ALAMEDA COUNTY, DEPARTMENT OF ENVIRONMENTAL HEALTH

Re: Addendum 2 to the Materials Management Plan for Phase II and Phase III of the EBMUD
Adeline Maintenance Facility construction sites.

Re: Addendum No. 2 to the Materials Management Plan for the Adeline Maintenance Center,
Oakland, California

PROPOSED BORING LOCATIONS		
DATE 8/3/96	SCALE 1"=100'	SHEET NO. deg
EBMUD AMC PHASE II SITE		
		Figure 6

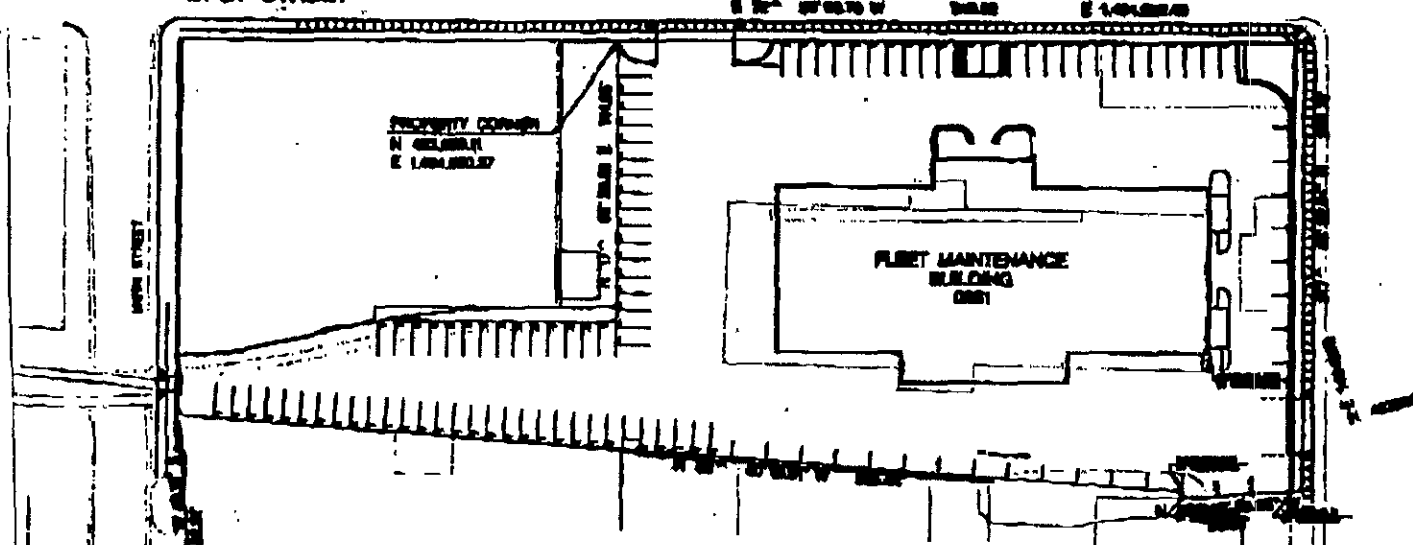
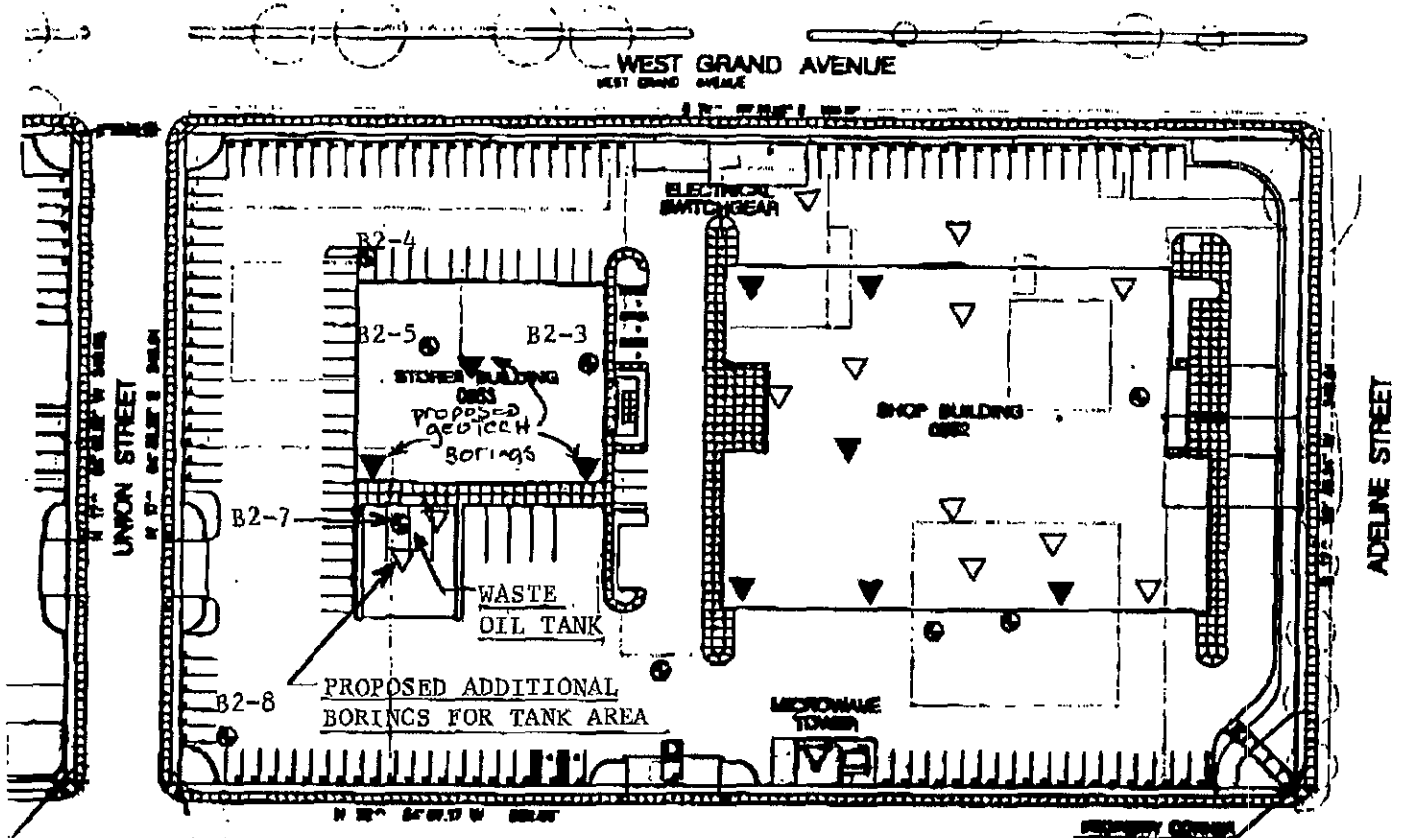
- o Per Figure 6 of the Addendum, two borings were proposed roughly in the area of former Boring 2-7 beneath the proposed building footprints. However, at least one additional boring should be placed in closer proximity to Boring 2-7 to better delineate the elevated contaminant levels previously identified in this boring. Contaminants identified in Boring 2-7 included elevated levels of Total Petroleum Hydrocarbons as gasoline (TPHg), benzene, toluene, ethylbenzene, xylenes (BTEX), TPH as diesel (TPHd), Oil & Grease, and halogenated volatile compounds. If the waste oil underground storage tank (UST) is located in the immediate vicinity, sampling associated with the removal of this UST may also assist in delineating the observed contamination.

The location of the waste oil UST is unclear. Please submit a figure with the exact location of this UST.

REMARKS: REVISED BORING LOCATION PLAN - NOTE
2 ADDED BORINGS COVER TANK AREA. BECAUSE
IT IS AT FOOTING IT WILL BE CONSIDERED
"WITHIN FOOTPRINT", THIS SHOULD HELP.

NOTE 2 ADDED BORINGS AT WASTE OIL TANK TO ASSESS CONDITIONS PRIOR TO REMOVAL. WILL FALL INTO "WITHIN FOOT PRINT" CRITERIA
